Subject: AP1000 DCD Impact Document Submittal of APP-GW-GLE-001, Revision 0

“Impact of Annex Building Expansion and Condenser Air Removal Stack Location on the Control Room  
Atmospheric Dispersion Factors”

**TITLE: Impact of Annex Building Expansion and Condenser Air Removal Stack Location on the Control Room Atmospheric Dispersion Factors**

This evaluation is prepared to document the Design Control Document (DCD) changes to Figure 15A-1, Table 15A-7, Table 2-1, Table 15A-6, and Table 5.0-1 (Tier 1). The DCD change is a clarification of the Annex Building Expansion and Condenser Air Removal Stack relocation's impact on the Control Room Atmospheric Dispersion Factors information contained in the AP1000 DCD. This change is intended to be included in the revision 17 of the DCD or be included as generic information in plant specific FSARs.

Figure 15A-1

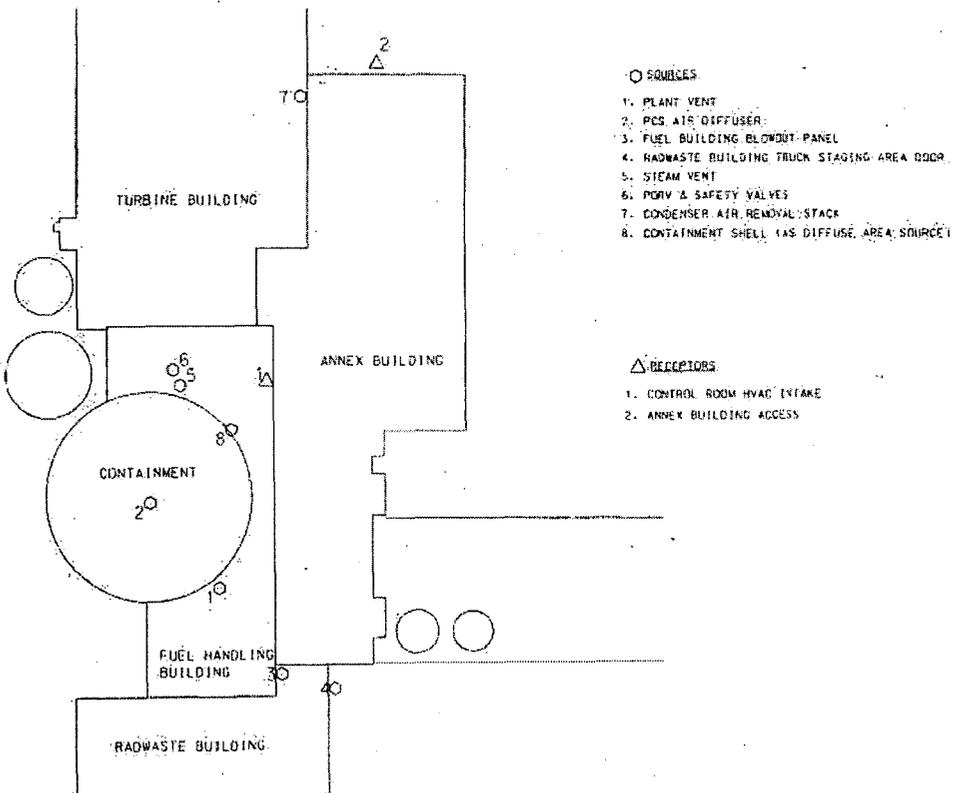
The revised DCD Table 15A-7 provides a listing of updated values for separation distances and release point elevations for use in determining the atmospheric dispersion factors (X/Q values) for the control room air intake and the Annex Building entrance (which provides the pathway for contaminated air entering the control room when the Control Room Habitability System is in service). The bases for the changes are Design Change Proposal "Annex Building Expanded Office Area," APP-GW-GEE-158, Revision 0 and Design Change Proposal "Outside Air Inlet Structure," APP-GW-GEE-228, Revision 0. In both cases, the distance from the sources to the receptors increased. (Refer to Figure 15A-1 attached). Additionally, the location of the condenser air removal stack was corrected to address an inconsistency between the illustrative DCD figure, Figure 15A-1, and the engineering design drawings. The revised DCD Figure 15A-1 and DCD Table 15A-7 are consistent with the layout shown in APP-GW-GEE-158, Revision 0. With the correction made to the location of the condenser air removal stack, there is an increase in the defined distance to the control room air intake and a decrease in the defined distance to the Annex Building access door.
